Drawing Title: ELECTRICAL 3RD, 4TH AND 10TH FLOOR POWER ONE LINE SCHEMATIC AND RISER DIAGRAM

Project Title: RENOVATE FOR CLINICAL IMPROVEMENTS

Project Number: 583C16254
Building Number: 1
Drawing Number: EP-600
3FY12

2 MH407 ENLARGED MECHANICAL ROOM PLAN
SCALE: 1/2" = 1'-0"

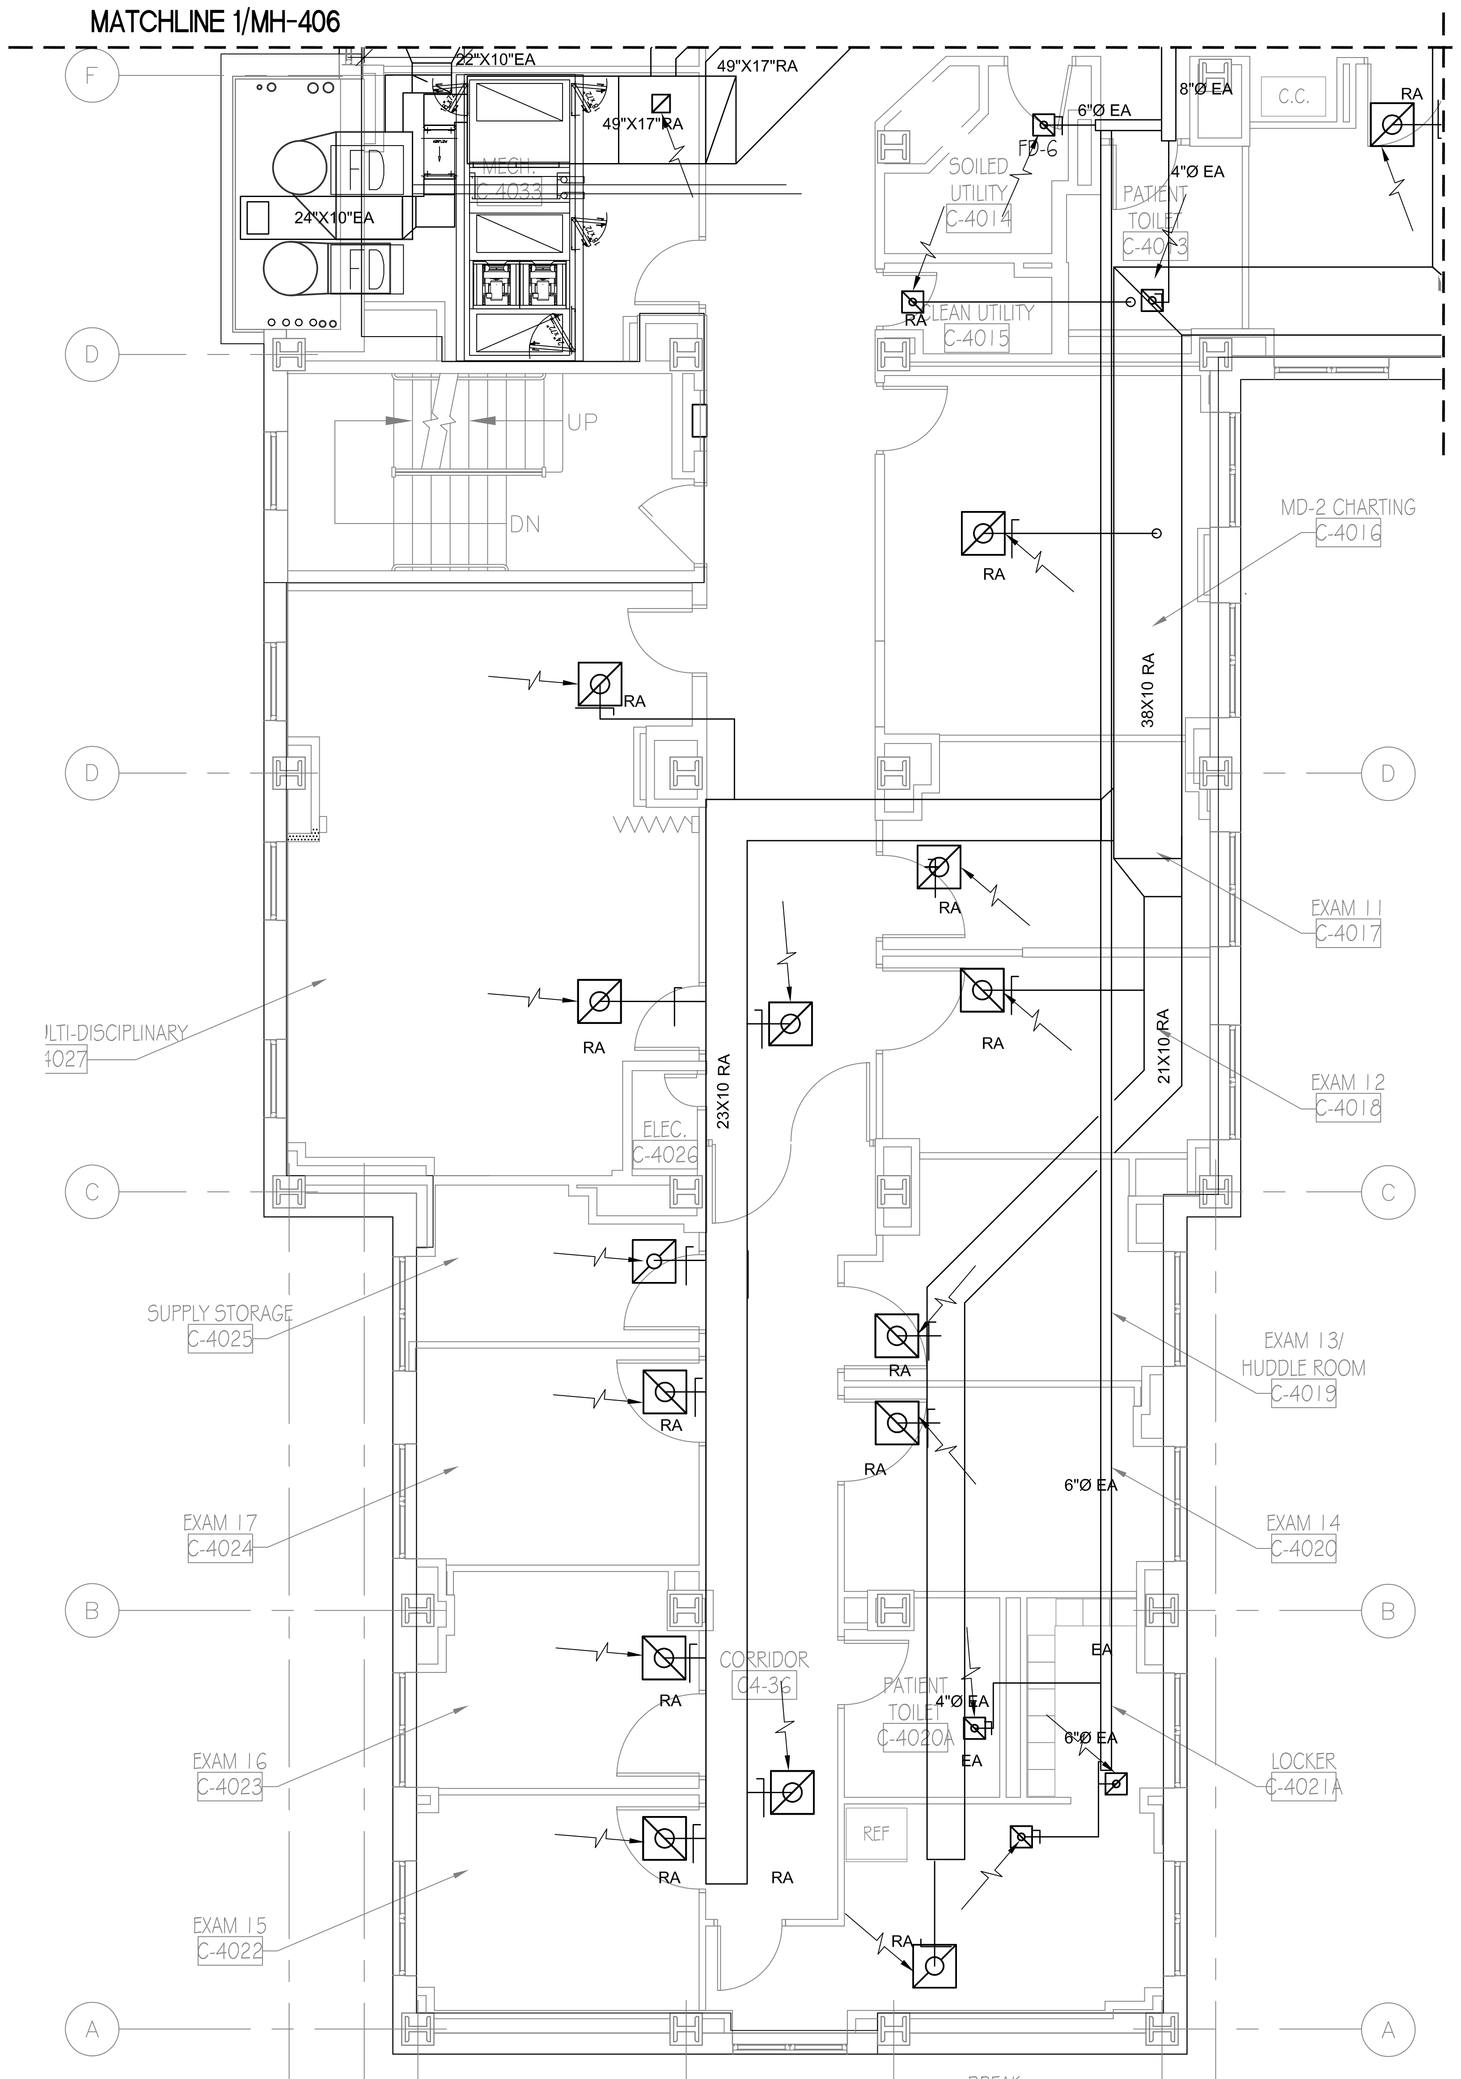
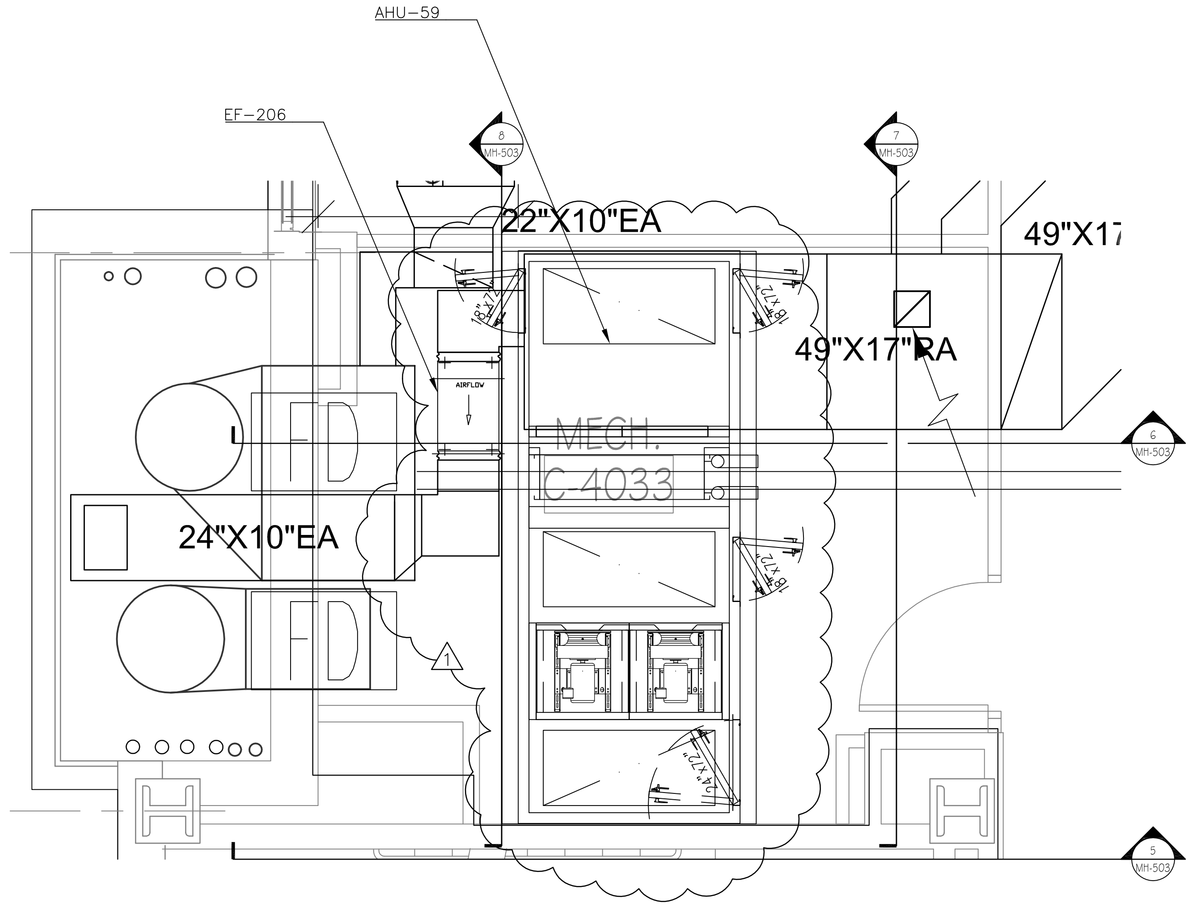
1 THE DRAWING ARRANGEMENT SHOWN IN DETAIL 2 SUPERSIDES ARRANGEMENTS SHOWN ELSEWHERE IN OTHER DRAWING PLAN ARRANGEMENTS(OVERALL AND MECHANICAL PLUMBING). THOSE SHOULD BE USE FOR REFERENCE ONLY. CHANGES SHOWN TO AHU-59 PERTAIN TO THE ARRANGEMENT OF THE AIR HANDLING UNIT SECTIONS AND INCLUDE AN OUTSIDE AIR CONNECTION TO THE UNIT. ADDITIONALLY NEW RELIEF AIR FAN EF-206 WAS ADDED FOR COMMON CONTROLS LIKE 3RD FLOOR WEST.

Revisions	Date
65% SUBMITTAL SET	01.07.2012
95% SUBMITTAL SET	03.07.2012
BID DOCUMENTS SUBMITTAL SET	05.14.2012
REVISION - CORRECTED AHU-59 ARRANGEMENT	8-28-2012
REVISION - ADDED EF-206	8-28-2012

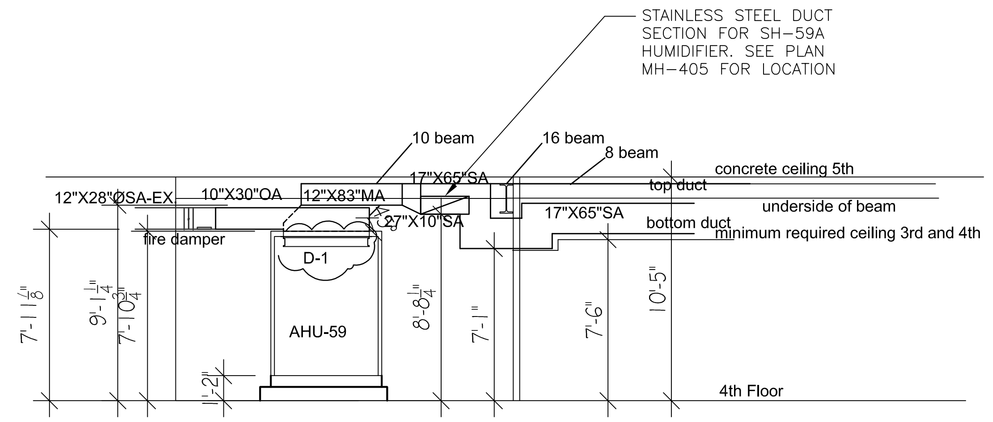
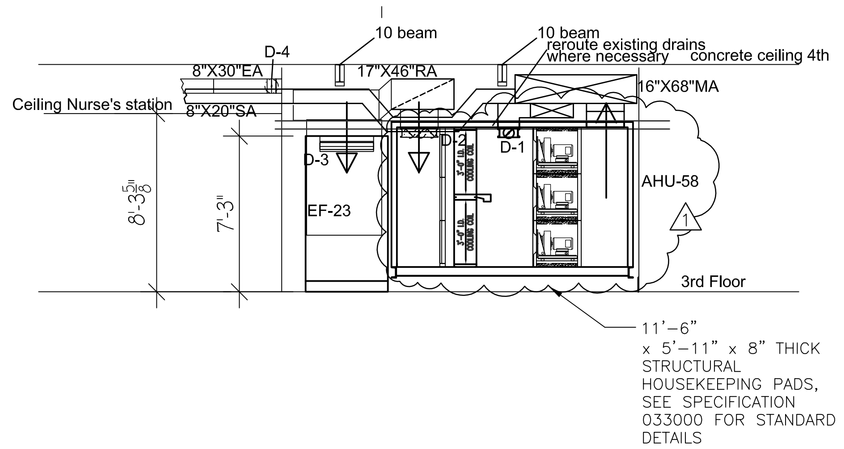
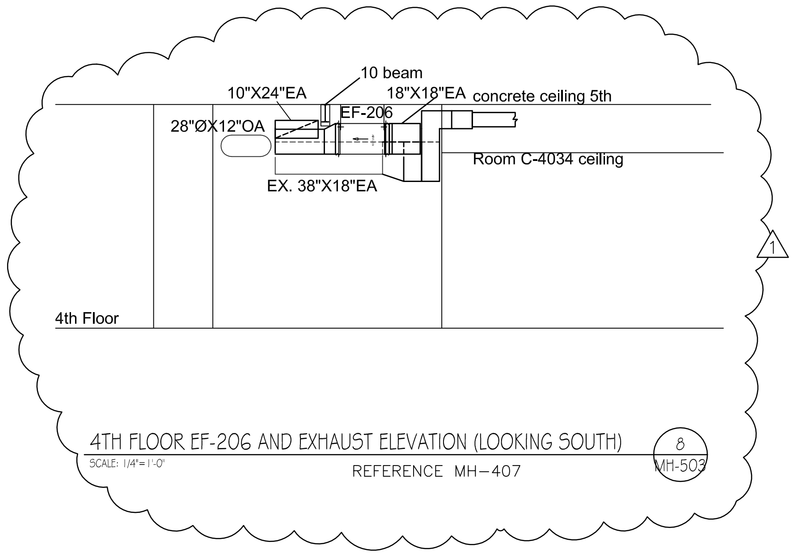
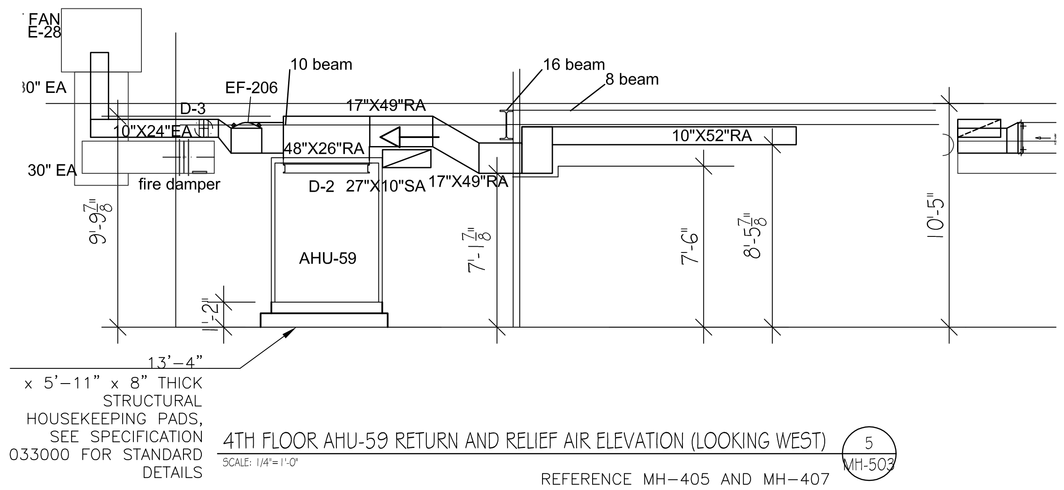
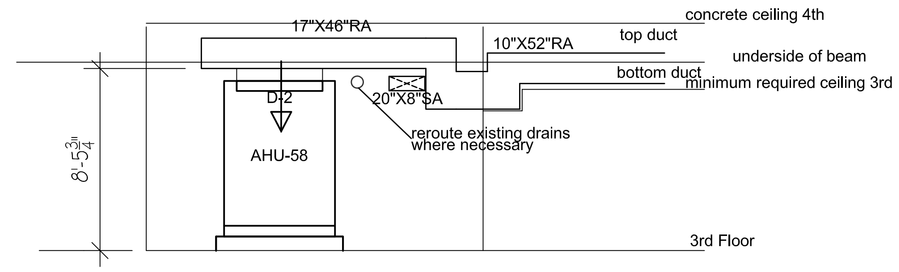
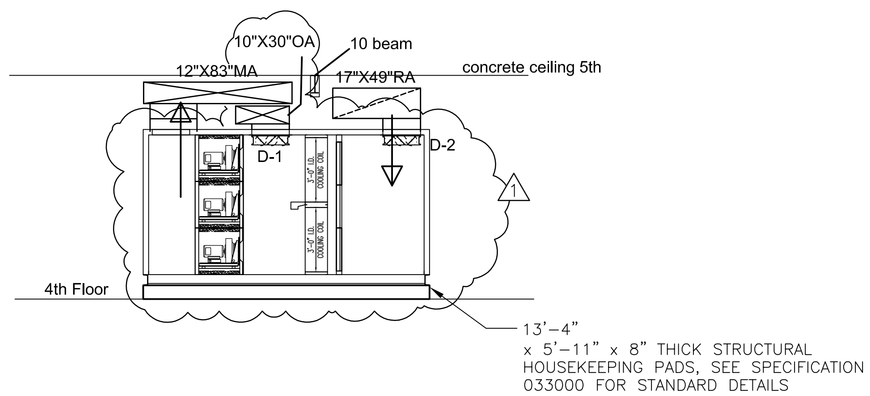
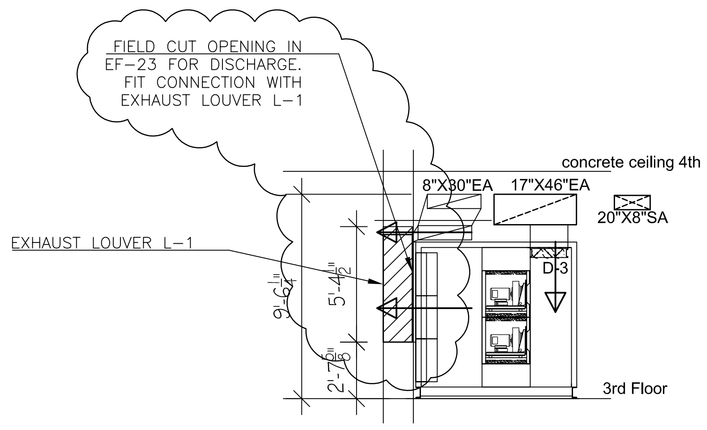
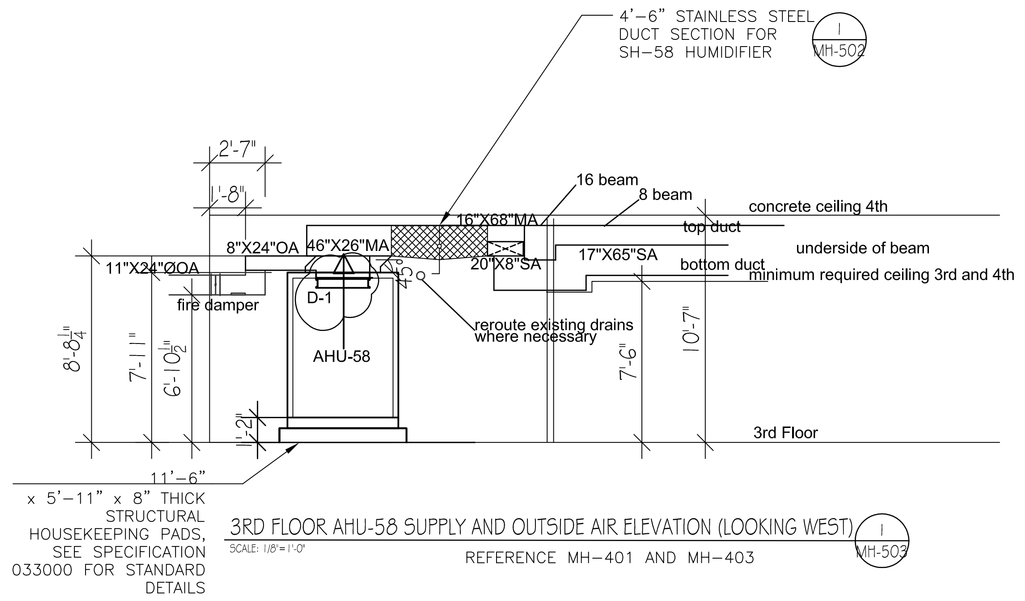
Revisions:	Date
65% SUBMITTAL SET	01.07.2012
95% SUBMITTAL SET	03.07.2012
BID DOCUMENTS SUBMITTAL SET	05.14.2012
REVISION - CORRECTED AHU-58 AND 59 ARRANGEMENT	8-28-2012
REVISION - ADDED OUTSIDE AIR DUCT TO AHU-58 AND 59	8-28-2012
REVISION - ADDED EF-206	8-28-2012

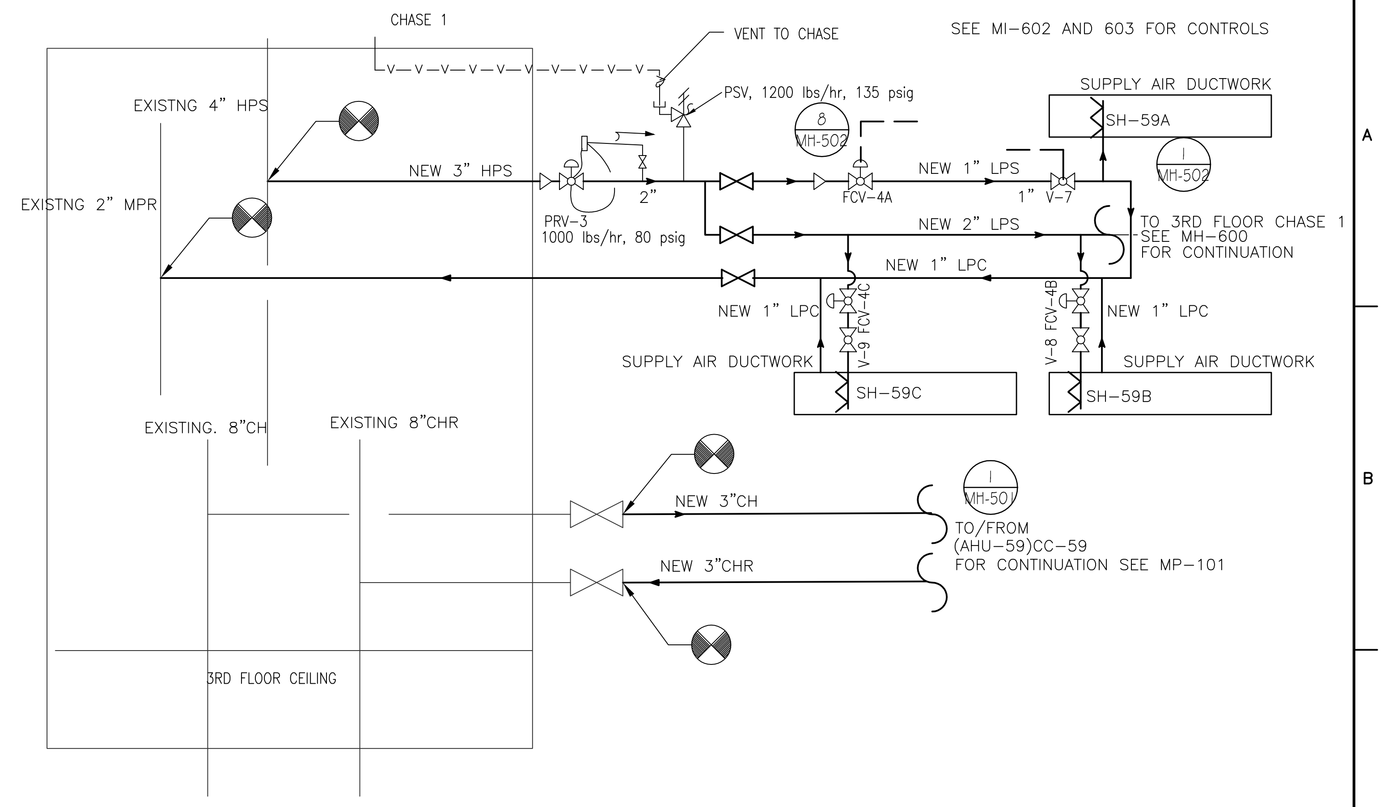
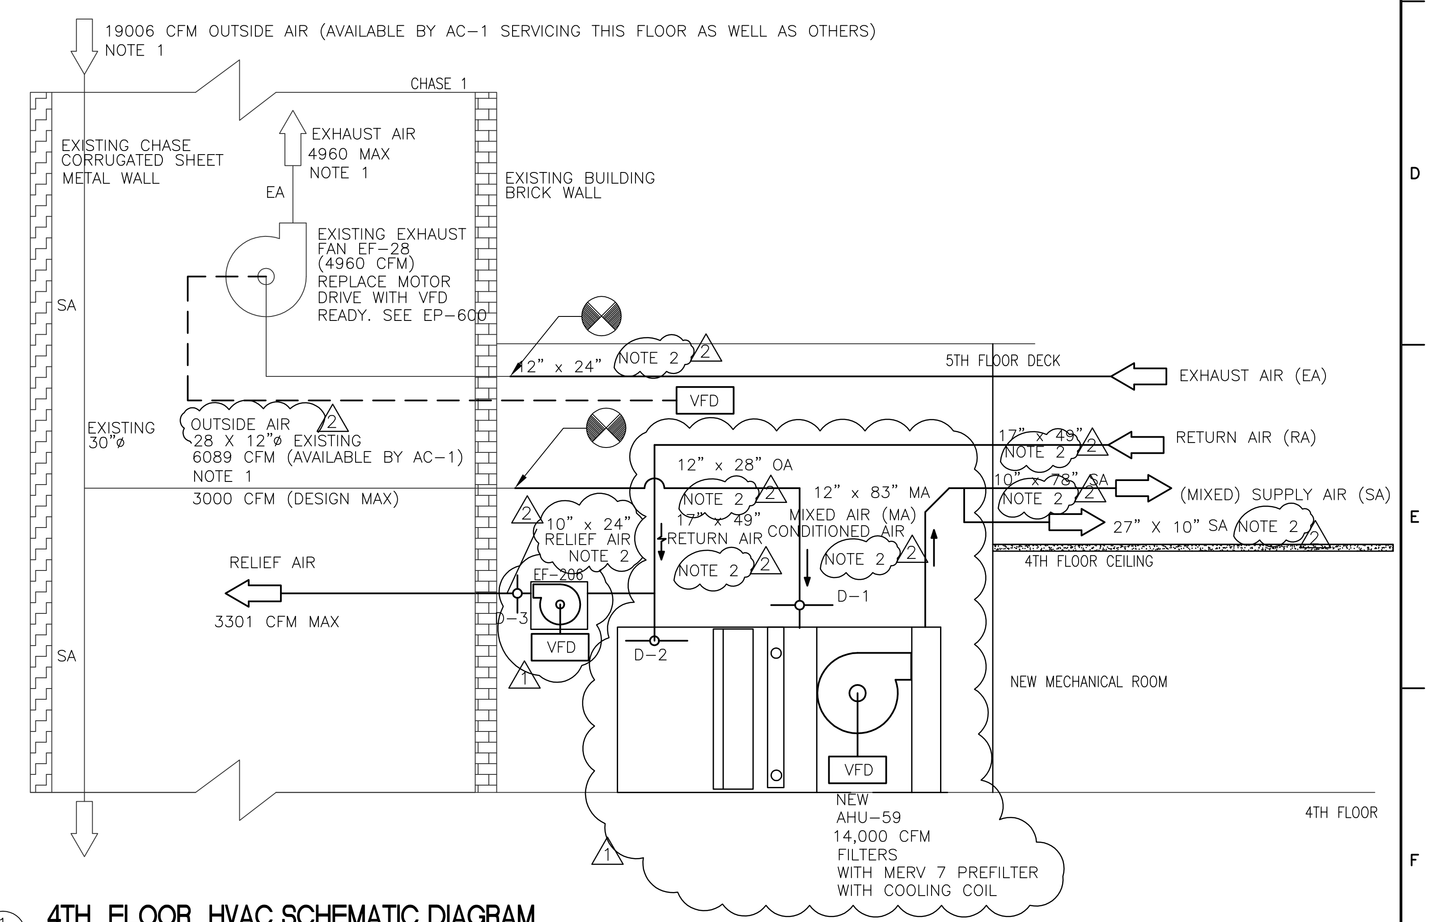
Revisions:	Date
65% SUBMITTAL SET	01.07.2012
95% SUBMITTAL SET	03.07.2012
BID DOCUMENTS SUBMITTAL SET	05.14.2012
REVISION - CORRECTED AHU-59 ARRANGEMENT	8-28-2012
REVISION - ADDED EF-206	8-28-2012
REVISION - CLARIFIED DUCTWORK SIZES AND NOTATIONS	8-30-2012
